Z-35
(2016)

CONCEPT PLAN FOR
EBENEZER CHASE
 LAND LOT 304 & 304, 16TH DISTRICT, 2ND SECTION
 COBB COUNTY, GEORGIA

PETITION NO: Z-35

ZONING COMMENTS:

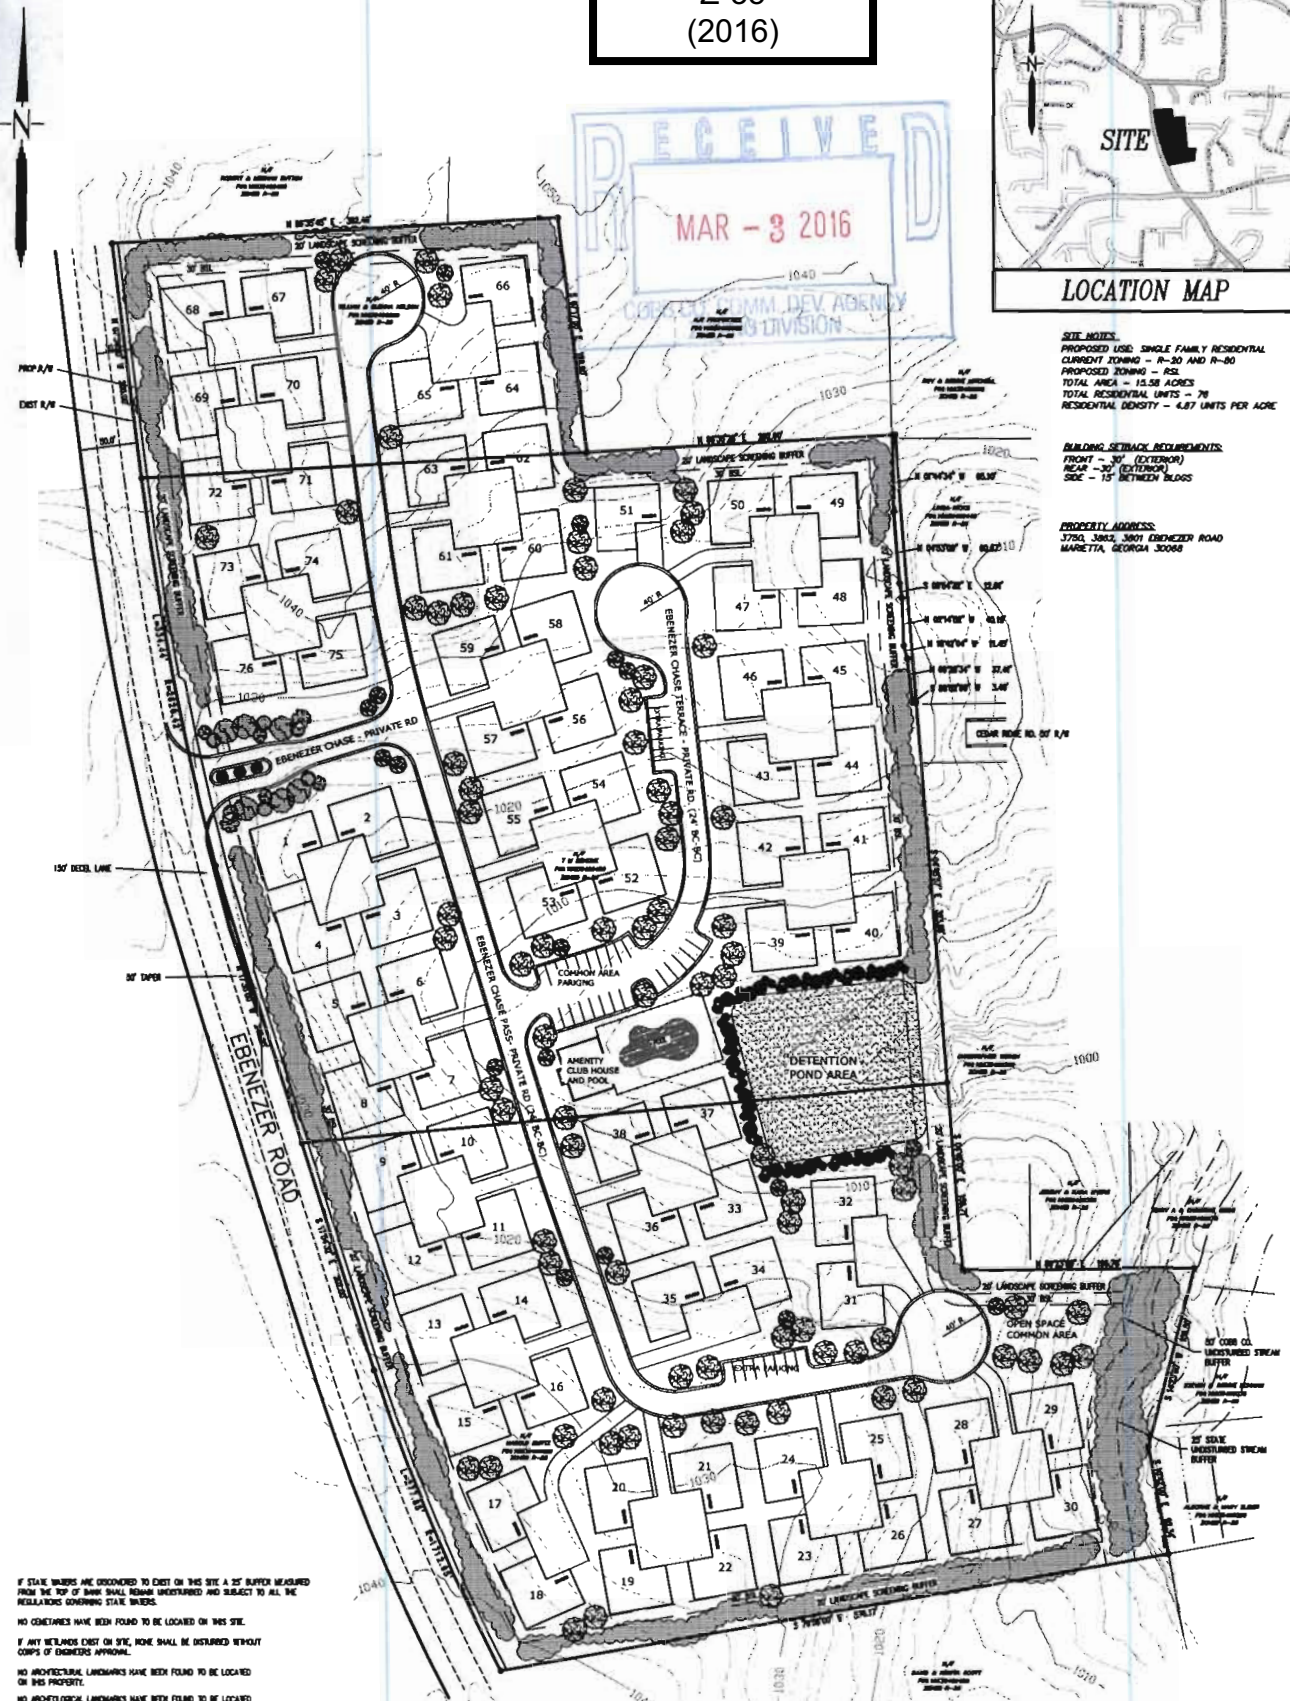
Applicant is requesting the Residential Senior Living (RSL) zoning district for the purpose of a 76-unit non-supportive senior living development. The units will be detached and arranged in quads. The units will be traditional one and a half stories, and will range in size from 1,750 square feet and up. Prices will range in from \$300,000 to \$450,000. The proposed development includes private streets, clubhouse and pool. The site plan indicates the required 20-foot landscape buffer abutting more restrictive residentially zoned properties.

- No Stormwater controls shown _____
- Copy of survey is not current – Additional comments may be forthcoming when current site conditions are exposed.
- No site improvements showing on exhibit.

Ebenezer Road is classified as a major collector and according to the available information the existing right-of-way does not meet the minimum requirements for this classification.

- D. It is Staff's opinion that the applicant's rezoning proposal is in conformity with the policy and intent of the *Cobb County Comprehensive Plan*, as far as being an allowed category in the Low Density Residential (LDR) land use category. However, the proposed density of 4.87 units per acre is not compatible with some of the abutting and nearby single-family residential subdivisions. These subdivisions include: North Ridge Unit Two (zoned R-20 at approximately 1.40 units per acre); Princeton Manor (zoned R-20 at 1.7 units per acre); and Kristen Trace (zoned R-20 at 2.169 units per acre). The area also includes single-family house on large tracts of land.

1. Board of Commissioners to approve final site plan, with the District Commissioner approving minor modifications;
2. Maximum density of 2.5 units per acre;
3. Water and Sewer Division comments and recommendations;
4. Stormwater Management Division comments and recommendations;
5. Department of Transportation comments and recommendations; and
6. Owner/developer to enter into a Development Agreement pursuant to O.C.G.A. §36-71-13 for dedication of system improvements to mitigate traffic concerns.
